NORTHERN WOLVES
AIR CONDITIONING

Project: **Sunrise Rye Brook - Independent Living / Assisted Living**

Mechanical drawings dated: 07.15.2026 (GMP set)

Mechanical Value Engineering Proposals

M5000 Hydronic flow diagram - boiler room

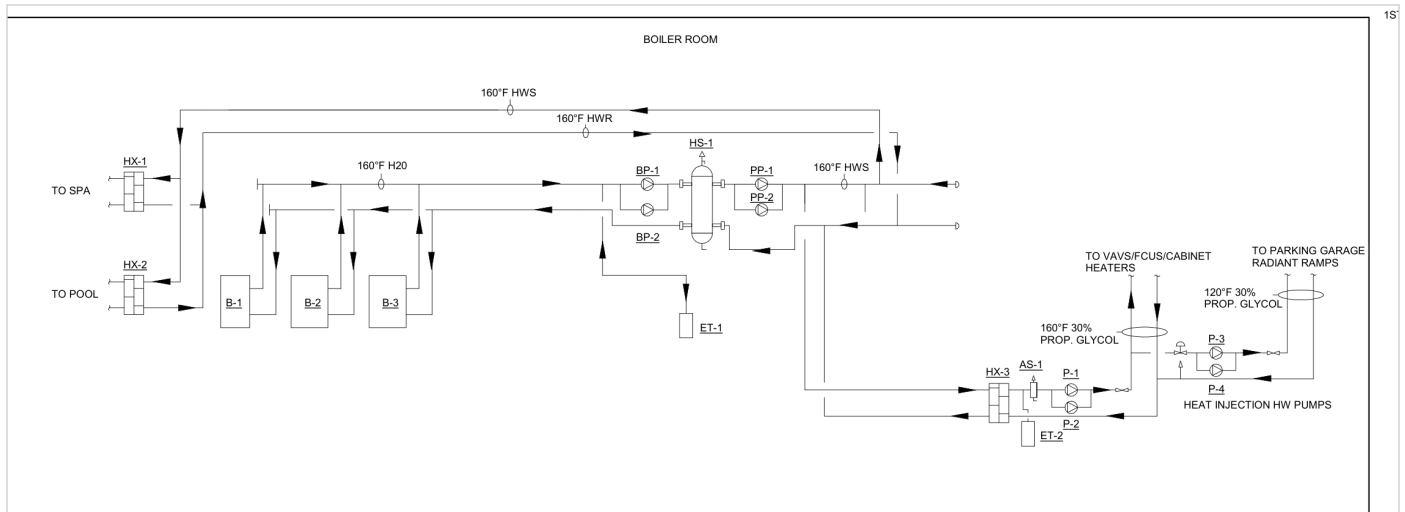
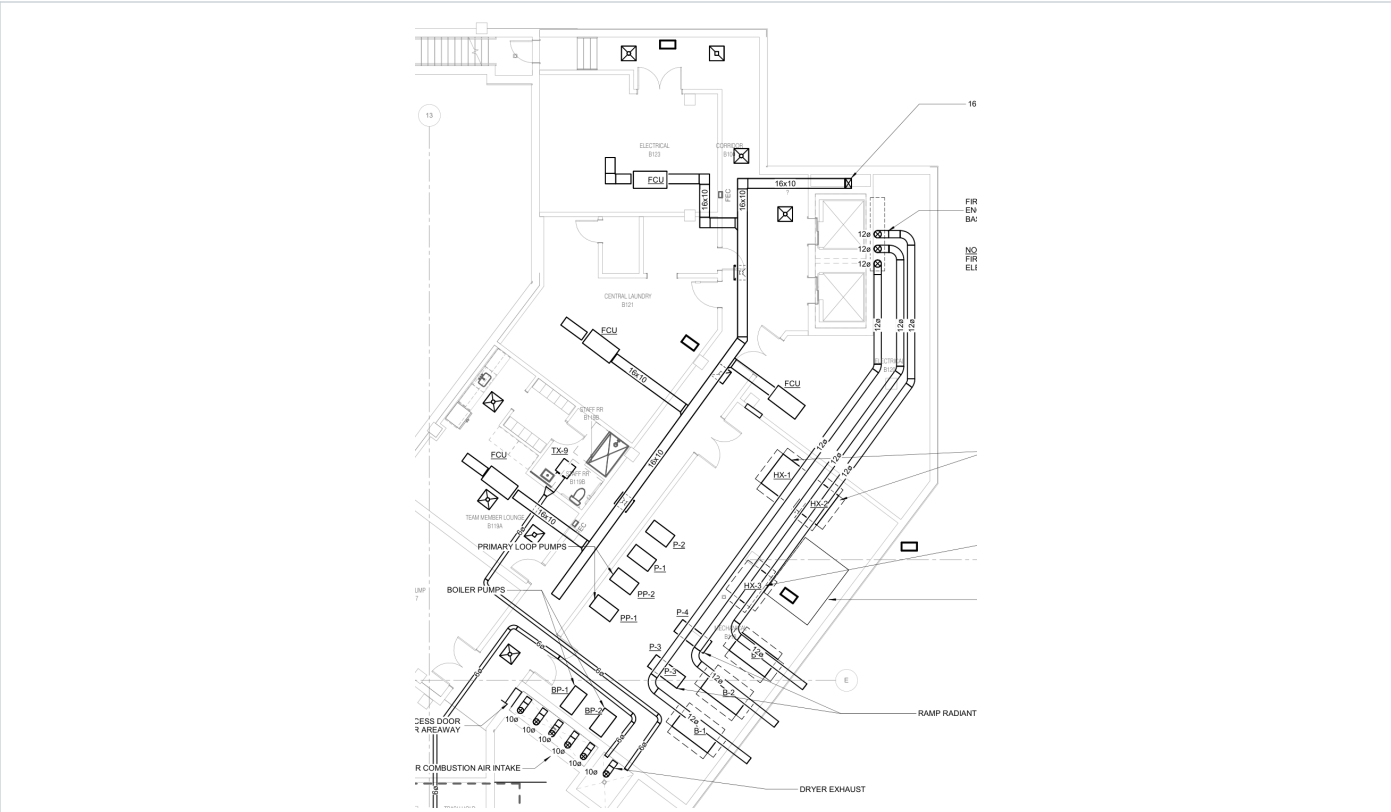
VE-01 Heating plant: delete boilers and hot water / glycol systems

- Three 1,999 MBH gas boilers B-1, B-2, B-3 (5,700 MBH output), primary / secondary with HS-1
- Pumps BP-1/2, PP-1/2, P-1 to P-4, expansion tanks ET-1/2, air separator AS-1, heat exchanger HX-3 to 30% glycol
- Fire-rated chimney enclosures basement to roof, combustion air areaway, water treatment, hot water and glycol distribution to the 1st floor and basement
- Connected heating load about 2,430 MBH: the plant is about 2.3 times the load

- Delete the boiler plant and all hot water / glycol distribution; the building runs on gas rooftop units, heat pump DOAS and the electric terminal heat in VE-02 to VE-06
- No boiler room equipment, chimneys, combustion air, water treatment, flushing or hydronic balancing
- Pool and spa heating by the pool contractor (by others)

Approvals / coordination: Requires VE-02 to VE-06. IMEG redesign; Sunrise approval.

Mark-up M2010 IL area A - reception / lounge / bistro and offices

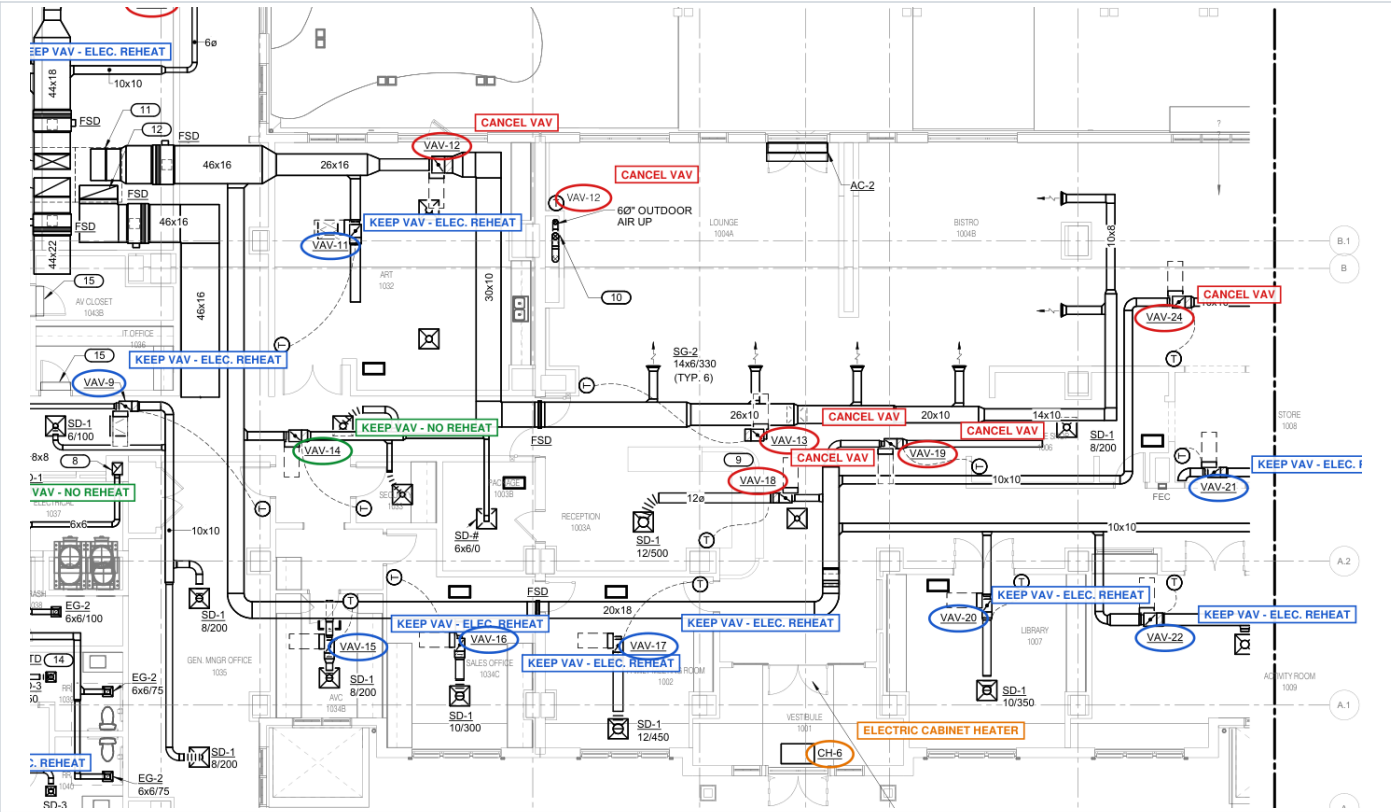
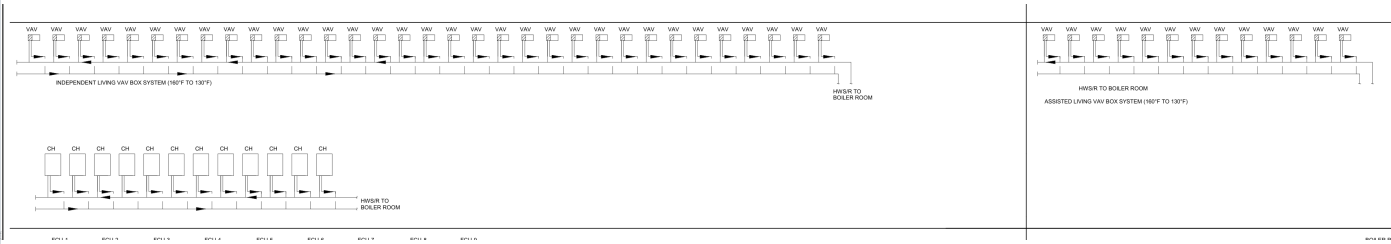
VE-02 VAV reheat: electric reheat only where needed

- 47 VAV boxes with hot water reheat coils (629 MBH, 45 GPM) on 5 rooftop units
- Hot water piping, control valves, balancing and insulation to every box (M2014 to M2016)

- Same rooftop units as designed (gas heat). VAV boxes kept in enclosed rooms (VE-03) get factory electric reheat coils with SCR control and a simple standalone thermostat: 25 boxes
- Interior / back-of-house rooms: VAV box kept cooling-only, no reheat required since the rooftop units are gas heat (VAV-8, VAV-14, VAV-31, VAV-32)
- No hot water piping, coil packages or control valves at any box. See mark-ups M2010, M2011, M2013

Approvals / coordination: IMEG redesign and energy code check (VAV minimums); electrical service capacity by EE.

Mark-up M2010 IL area A - multi-purpose, theater, salon, offices, corridor

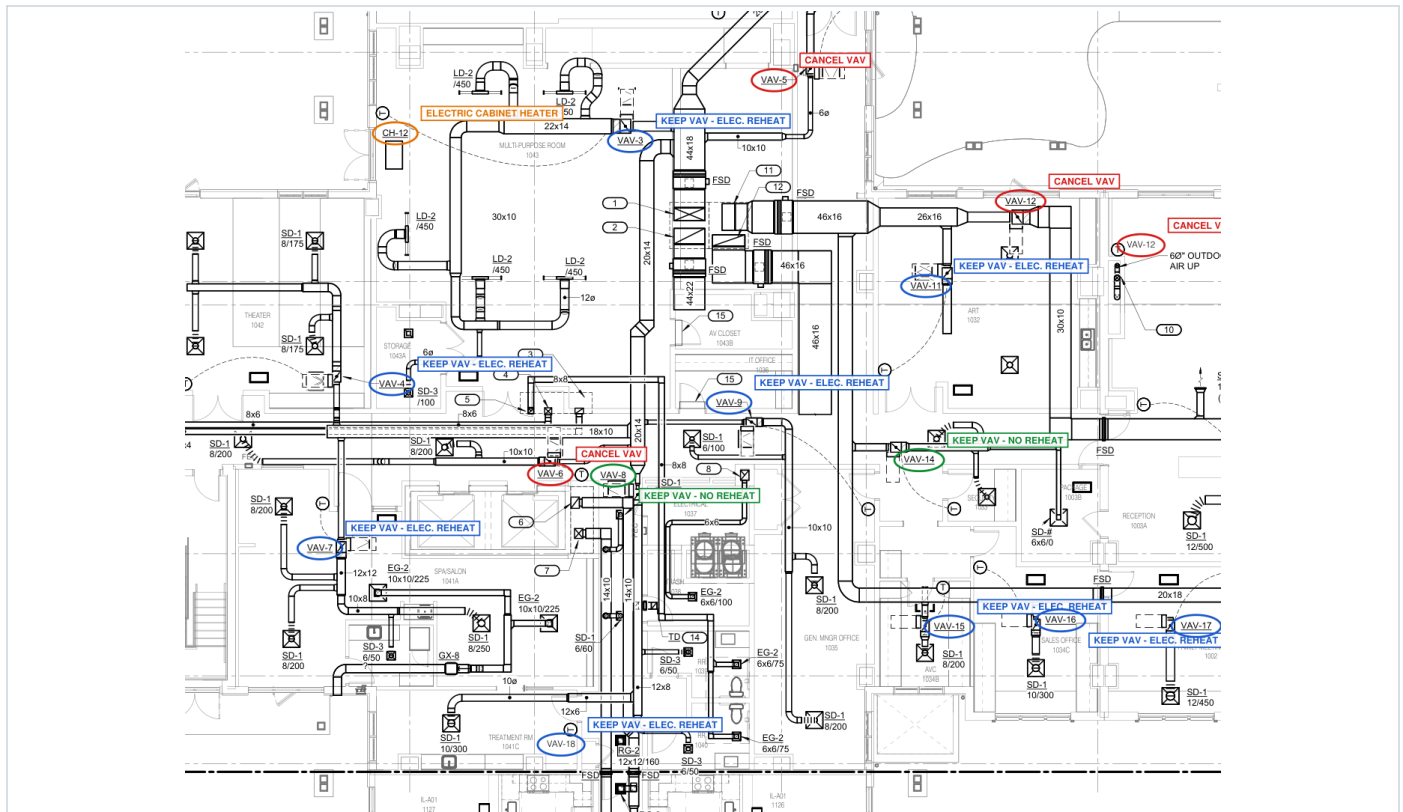
VE-03 Common areas: cancel VAV boxes in open areas and circulation

- Same rooftop units and main ductwork as designed. Cancel 18 VAV boxes in open areas and circulation (lounge, bistro, coffee shop, reception, formal / casual / AL dining, parlor, kitchen, corridors, restrooms)
- Branch ducts stay, with manual volume dampers balanced to the design maximum CFM; the area is served directly by its rooftop unit (rooftop unit space sensor in that area), gas heat from the rooftop unit
- VAV boxes stay only in enclosed rooms (offices, theaters, activity, fitness, salon, private dining, library, family rooms) - see VE-02. No ductless units added

- Each box is marked on the attached mark-ups: CANCEL VAV / KEEP VAV - ELEC. REHEAT / KEEP VAV - NO REHEAT

Approvals / coordination: IMEG zoning review (rooftop unit control zone per unit); Sunrise approval.

Mark-up M2010 - CH-12 and other entries

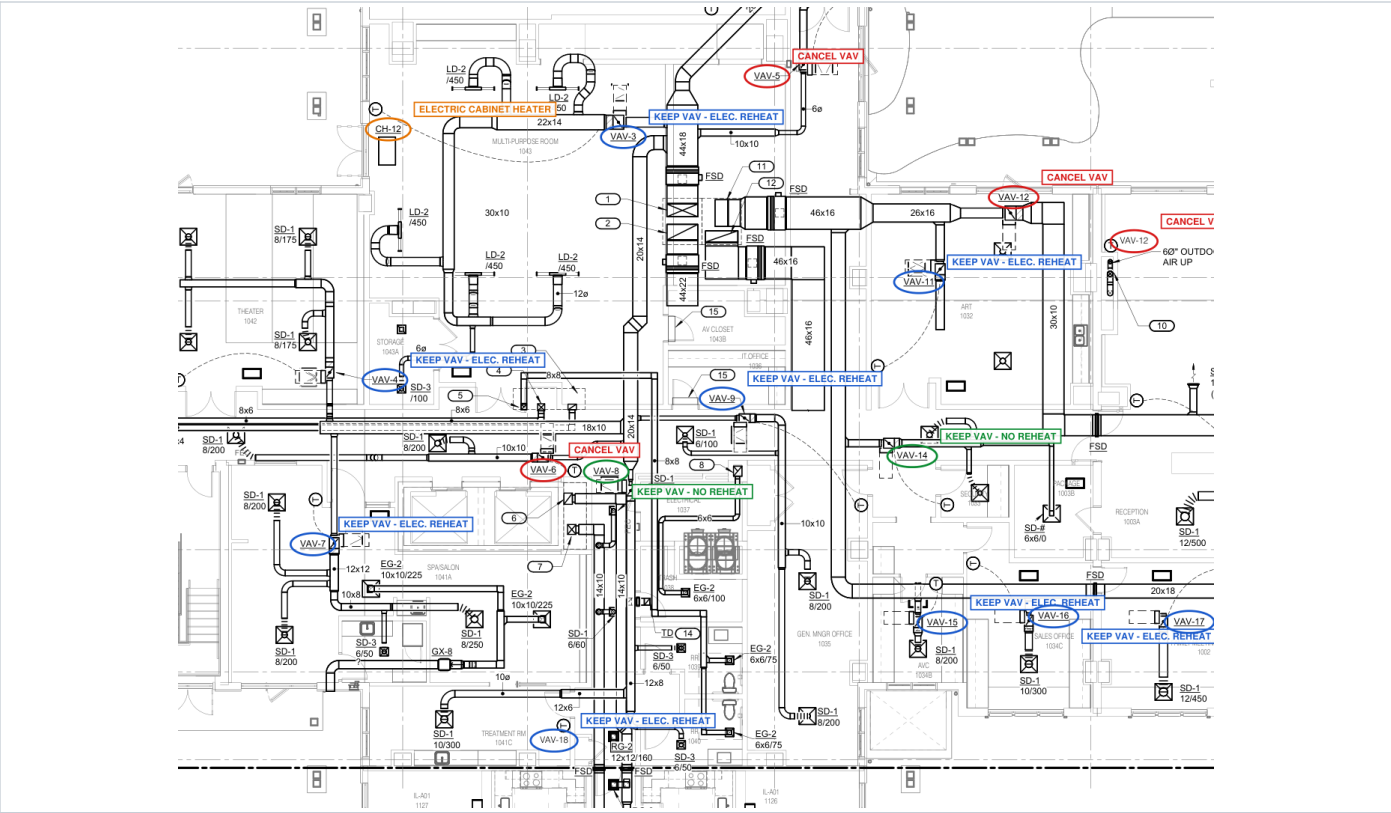
VE-04 Cabinet heaters: hot water to electric

- 11 hot water cabinet heaters in the schedule (CH-8 not shown on plans) with piping and BMS control

- Electric cabinet heaters with integral thermostats at the same locations; no piping, no BMS points. Each heater is marked on mark-ups M2010 and M2011

Approvals / coordination: IMEG; EE.

Mark-up M2002 AL basement - storage, corridor, staff lounge, mechanical, electrical, laundry

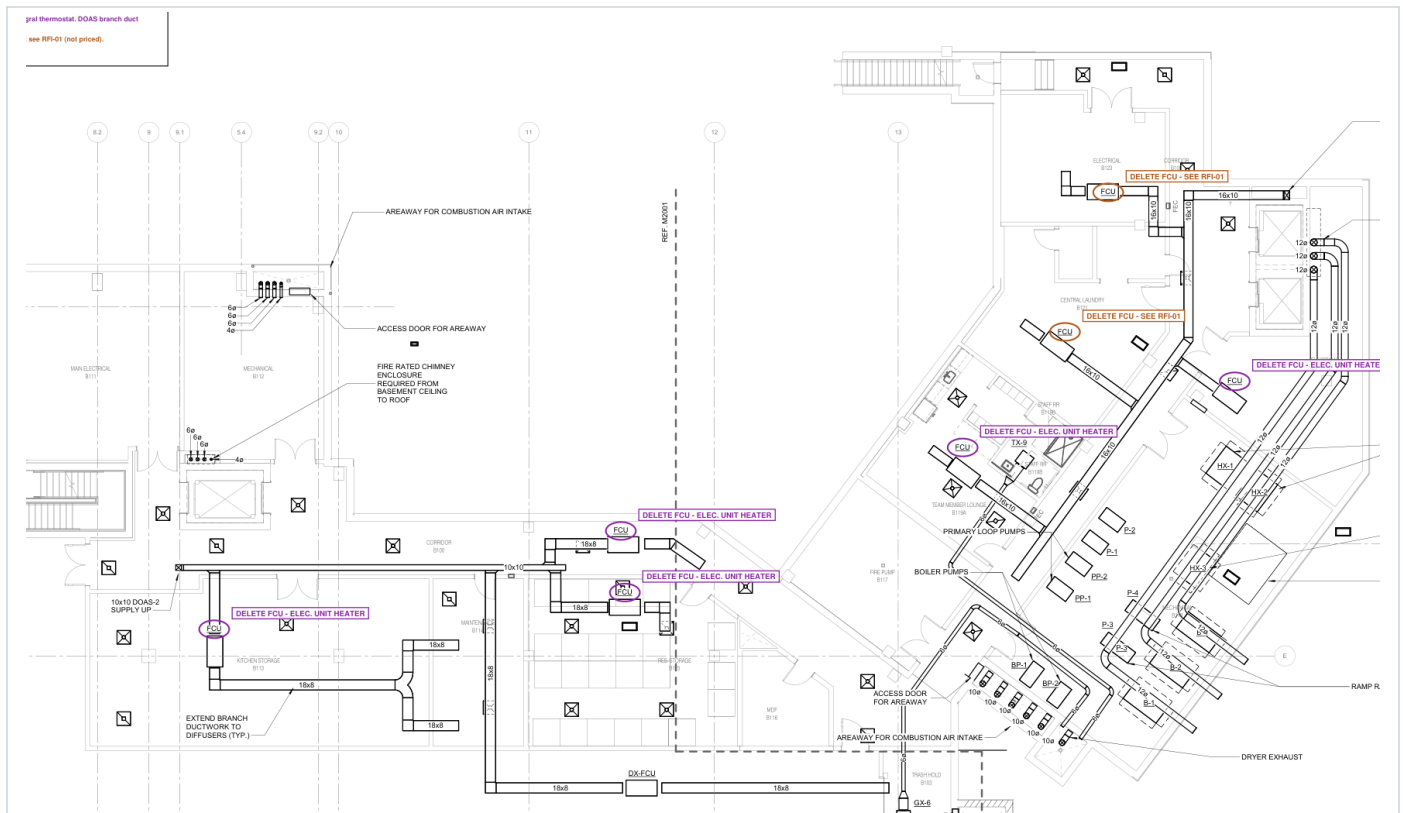
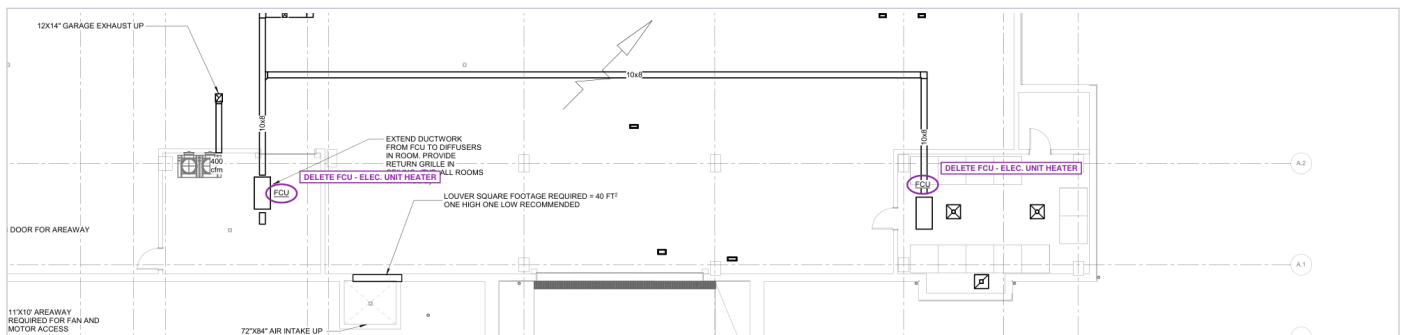
VE-05 Basement fan coil units: electric unit heaters

- FCU-A, quantity 20, "basement heating", hot water / glycol heating coil only (schedule data blank); M5000 shows FCU-1 to FCU-17 on the glycol loop with RAD-1/2
- Each FCU takes a small DOAS branch at its inlet and recirculates the room
- No glycol or hot water piping to these units is drawn on M2001 / M2003

- Delete the FCUs and RAD-1/2. Electric unit heater with integral thermostat in each room that had an FCU (storage, trash, corridor, staff lounge, mechanical); DOAS branch duct extended directly to the room diffuser, return grille deleted. Each unit is marked on mark-ups M2000 and M2002
- Electrical room B123 and central laundry B121: FCU deleted; these rooms need cooling / ventilation, not heat - see RFI-01 (separate page, not priced)

Approvals / coordination: IMEG; fire protection designer to confirm freeze-protection locations.

M5000 Hydronic flow diagram - basement FCUs, RAD-1/2 and ramp snow melt loops

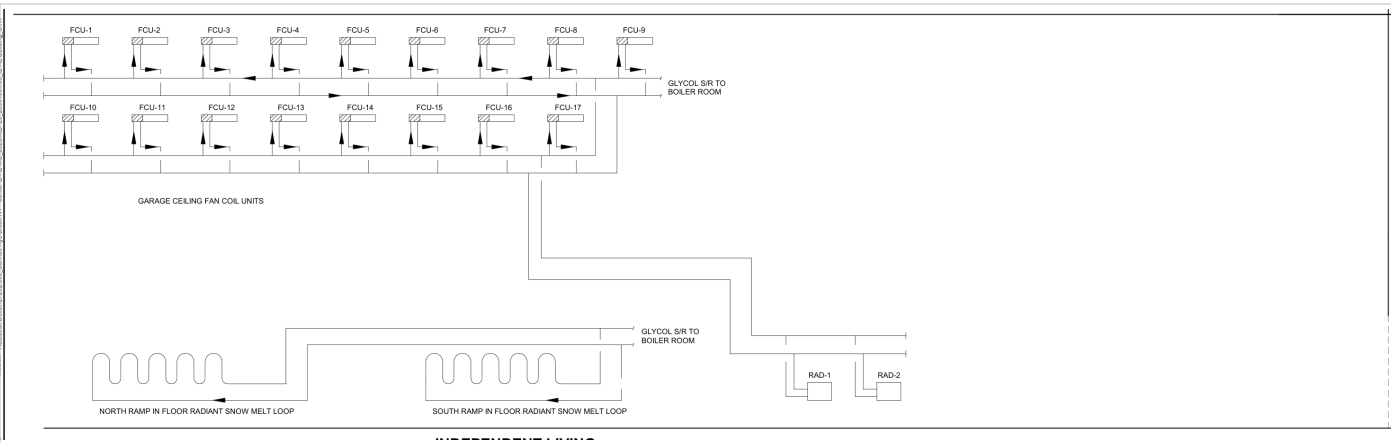
VE-06 Garage ramp snow melt

- In-floor radiant snow melt loops on both ramps from the boiler plant through HX-3

- Option A: no snow melt; trench drains and salting (owner decision)
 - Option B: electric snow melt cable by EC, storm-only operation with load shedding
- Benefits: Removes the long glycol mains from the boiler room to the ramps and the snow melt pumps.

Approvals / coordination: Owner decision; civil / landscape for drainage.

M2023 AL 2nd floor - DOAS corridor ducts, FSD at shaft and note for all units

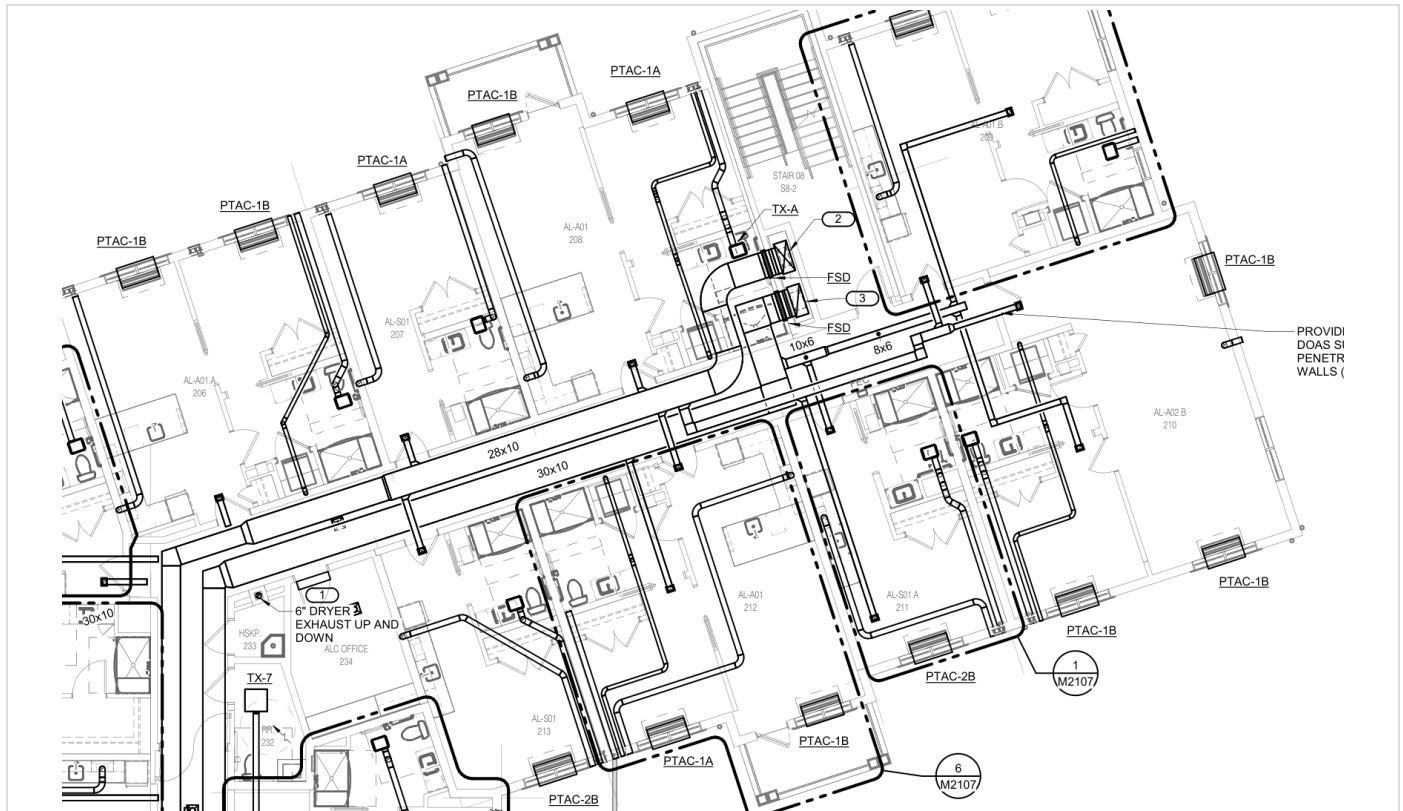
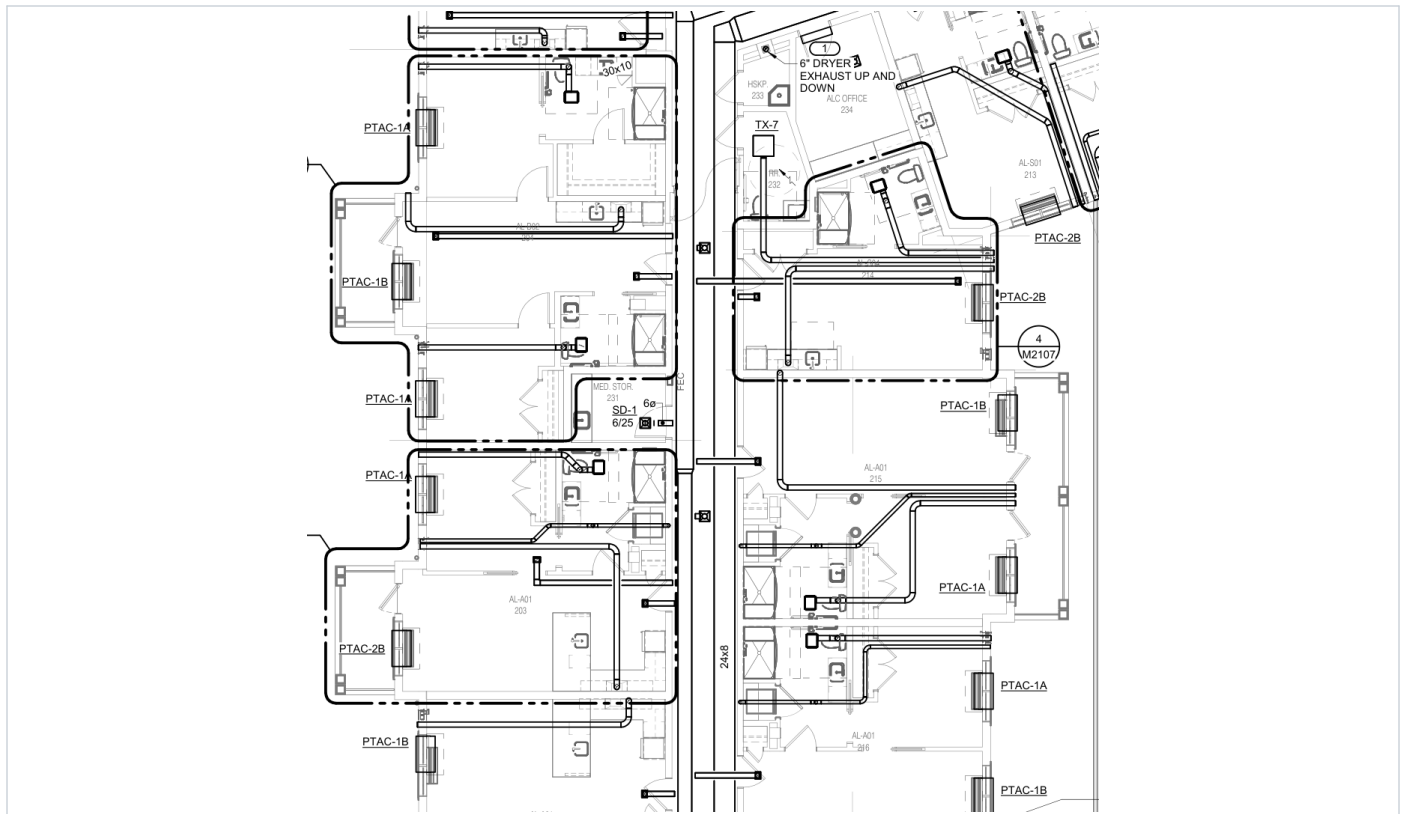
VE-07 Fire / smoke dampers at apartment duct branches

- Combination fire / smoke damper at every DOAS supply / return branch into each apartment (M2023 note: "provide fire/smoke damper at all DOAS supply/return penetrations through demising walls")
- Each damper needs power, fire alarm interface, access door in a finished ceiling and periodic testing

- Apartment branches (6x4 to 8x6) under 100 sq in, 26 ga steel, no openings into the corridor, above the ceiling, with 12" steel sleeve: no damper required at the corridor fire partition (IBC 717.5.4 exception); plain fire dampers as fallback
- Fire / smoke dampers kept at shafts and smoke barriers

Approvals / coordination: IMEG / HKS code analysis (AL Group I-1 smoke barriers), building department.
